ANN ARBOR HOUSING BOARD OF APPEALS

STAFF REPORT

Type of Request: VARIANCE

Housing Board of Appeals Request **HBA22-2001** at 227 Orchard Hills Dr, ANN ARBOR, MI 48104.

This is the FLW Palmer House,
with eight 4" risers and 18" treads.

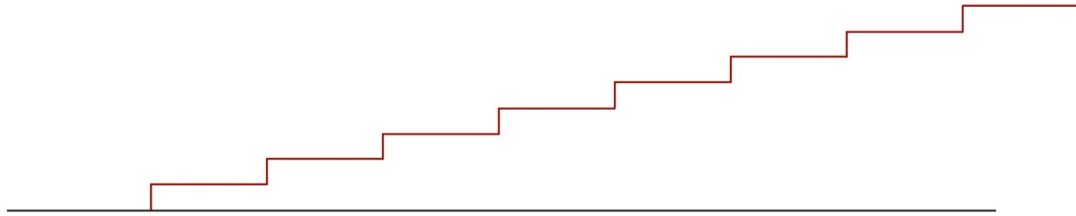
Front Entrance: The front entrance of the Palmer House, which was featured in a Chrysler advertisement and is arguably the most important view of the house, has a series of eight 4” risers (half the height of a normal step) with 18” treads (twice the depth of a normal step).

The Housing Board has asked us to modify the structure of the Palmer House and install an 11-foot handrail. Adding a handrail of this length would compromise the horizontal lines of the front entrance designed by Frank Lloyd Wright and would break my promise to the Palmer family. I cannot do this. Instead, I hope to persuade you that the current eight risers without a handrail are at least as safe, if not safer, than a normal staircase with a handrail.

- Staff is unable to support granting of this variance. The housing code requires a handrail at all flights of stairs with 4 or more risers. This is similar to the current building code requirements found in the 2015 Michigan Residential Code and previous versions. Each stair within the flight of stairs in question are half the rise (4" riser) and twice as deep (18" treads) as allowable. The low slope of the stairs does not constitute omission of the required handrail. The 2015 Michigan residential Code requires a handrail on ramps exceeding a slope of one unit vertical and 12 units horizontal (8.33 percent). The slope of this flight of stairs is 25 percent, 3 times as steep as a ramp requiring a handrail. While accessibility is not required in single family homes, it would be unreasonable to expect a person with a wheel chair or walker to climb stairs as suggested in the owner's appeal. The code at the time of construction (Official Building Code of Ann Arbor-1929 Council Proceedings) is ambiguous and can be interpreted to require no handrail, or a handrail on one side. It is the cities interpretation that the intent was to require a handrail on one side. This is ultimately not relevant since the housing code is applicable to all dwellings without regard to whether they were constructed before or after the effective date (8:501 application of chapter).

This is a normal staircase,
with four 8" risers and 10" treads.

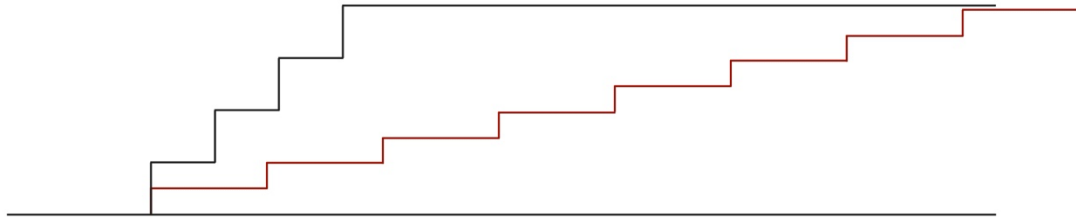
As mentioned above, the 4" risers are half the height of a normal step and the 18" treads are twice the depth of a normal step. Under previous versions of the Michigan housing code, these risers are so short and the treads so deep that they would not even be considered stairs. The challenge here is that the current Ann Arbor housing code simply does not contemplate risers this short and treads this deep. The front entrance rises roughly 30" over 10 feet, while a normal staircase would use just over 2 feet for the same rise.

This is a normal staircase and the FLW Palmer House, rising the same height, but over drastically different distances.

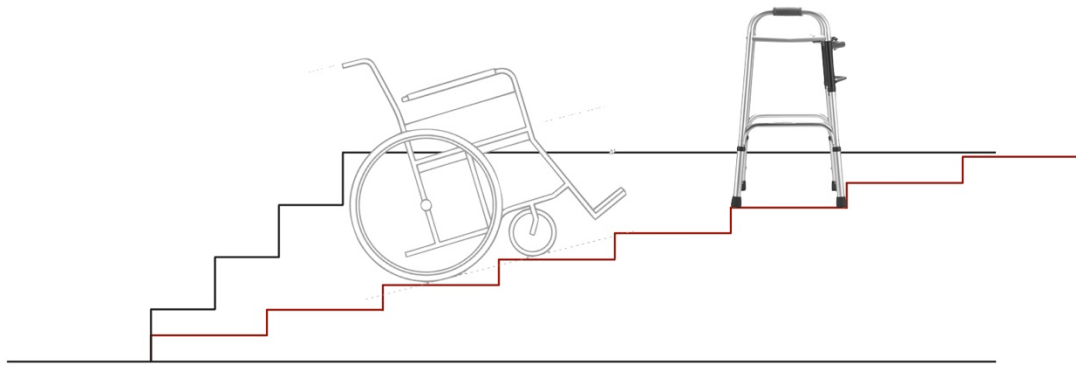
In addition to being safe, the front entrance of the Palmer House is significantly more accessible to more people, as the 4" risers are so short that they safely accommodate all four wheels of a wheelchair and the 18" treads are so deep that they safely accommodate all four legs of a walker. A guest in a wheelchair could *roll themselves* up the front entrance.

This is an alternative staircase, with four 8" risers, interrupted by a five foot landing. The landing, under the housing rules, eliminates the safety requirement for a handrail.

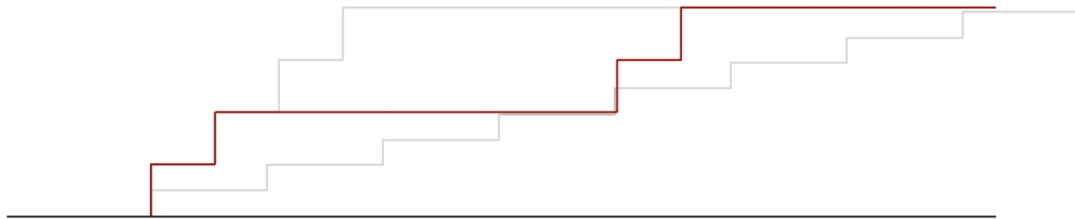
Alternative Design: If the request for a variance is not approved, we would likely seek a permit to extend the height of the risers to create four 8" risers interrupted by a five foot landing, as shown below.

Both the first set of two steps and the second set of two steps would not be “continuous and uninterrupted”. Because both sets only have two steps each, this alternative design would not require a handrail under Michigan housing rules. I do not want to pursue this alternative design (because it is both expensive and clearly less accessible), but the alternative design would not compromise the horizontal lines of the front entrance and would not require any modification to the structure, thus keeping my promise to the Palmer family.
